Seattle Design Commission

MINUTES OF THE MEETING

October 18, 2007

Fire Station 37 Site Map

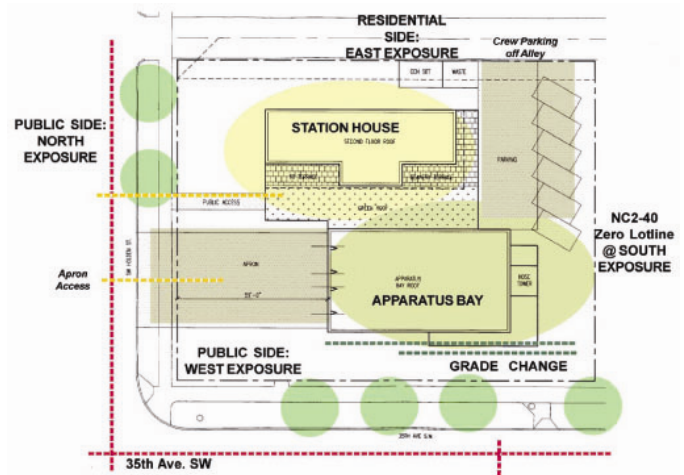
- **Questions the north-facing terrace and suggests the quality of space needs more study.**
- **Commend design refinements from last presentation.**
- **Encourages the new dramatic roof to be entirely green.**
- **Strengthen the northwest corner by taking the glass wrap even farther and remove the tree to improve the visibility.**
- **Encourage a more powerful storm water cycling showcasing of water with drain-off tower in the southwest corner and use of a stronger element for the drains.**
- **Applaud sustainable design (i.e. rain garden)**
- **Urge team to take another look at fenestration and materials.**
- **Thanks team for bringing landscape plans.**
- **Believe this is an elegant solution to the design problem at hand.**

- Is the green roof visible from the street?
 - o No, it is more like a private yard for firefighters.
- What are the exterior materials?
 - o CMU, slatecrete and glazing and sliding doors.
- Where can there be cross-ventilation?
 - o Possibly in the apparatus bay.
- What about the north-facing terrace?
 - o The wall will be pulled back.

- Will the green roof be sloped?
 - Greatest and most dramatic views will be from below, so more for storm water on site.
- Like the consolidation of forms and parts all under one roof.

- What energy systems are there?
 - New city multisystem is being explored that balances heat and air control needs of site.
- The team can make corner windows big enough to extend and wrap more especially for passerbys on 35th Avenue Southwest

- This plan has a very elegant scheme and seems to be headed in the right direction.
- Keep roof as lean and light as possible, if it is not green.
- Regarding the covered roof: make sure that it is not too dark under and that the upper roof garden has a through walkway.

- The northwest corner is not as strong as it could be; make it visible, break trees there, and make more open.
- Celebrate roof runoff more. Chain drains are too similar to cables. Make it stand out against the hose tower.

- The artist will likely target the northwest corner.
- Fenestration patterns are too much, so simplify.
- Really nice to see the landscape at this mid-stage.

South Spokane Street Viaduct Widening Project Plan

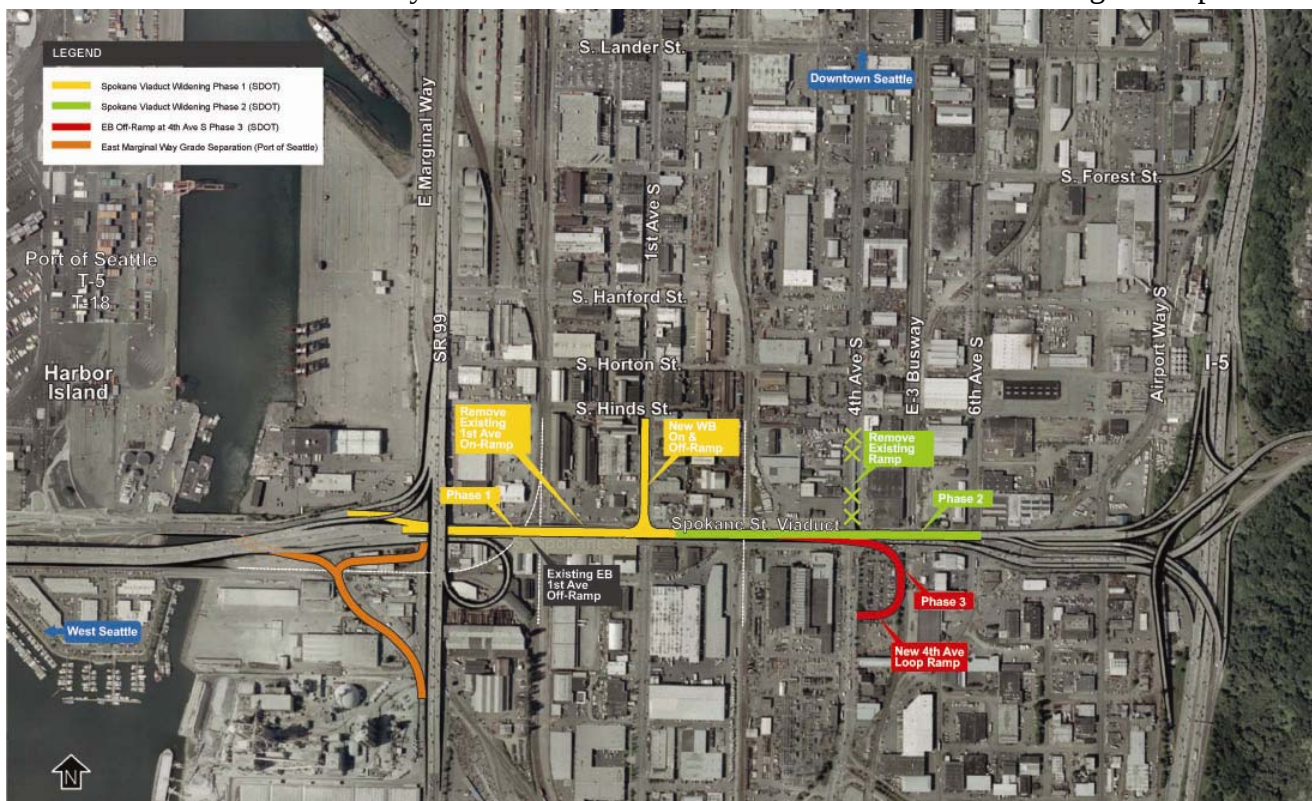
- o **Appreciate that the team is moving ahead, and to that end the Commission encourages the team to look internally at SDOT Art Plan for creative aspects to the project that might be easy to include.**

- o **Safety is the most important for pedestrians, vehicles, and bikes, so find effective ways of mitigating this issue.**
- o **Concern for the landing near Seattle City Light Parking lot.**

- o **Take another pass at design treatments of outriggers.**
- o **Appreciate landscaping and lighting which can help improve circumstances of site.**
- o **If it is not possible to provide a design amenity on the outrigger columns, then provide an improved bus shelter on South Spokane.**

- o **Partner with City Light regarding potential incorporation of art into this project since the ramp is adjacent to their building; suggestion of a lighting panel or solar panel on the outriggers, as well as potential partnering on art opportunities for the project.**

- What is the design of outriggers? Perhaps the tem could look into a more enhanced design for the outriggers and columns.
 - They will have a distinct look and feel from the main Viaduct structure. The team will not look at them as art, although it could provide a design opportunity. However, it needs more architectural treatment.

- See concrete walls as canvas, so the team can use concrete as a statement itself. The team should explore ways that artwork can enhance or mediate the impacts of the progression of outriggers and what it does to both the auto/truck and pedestrians.
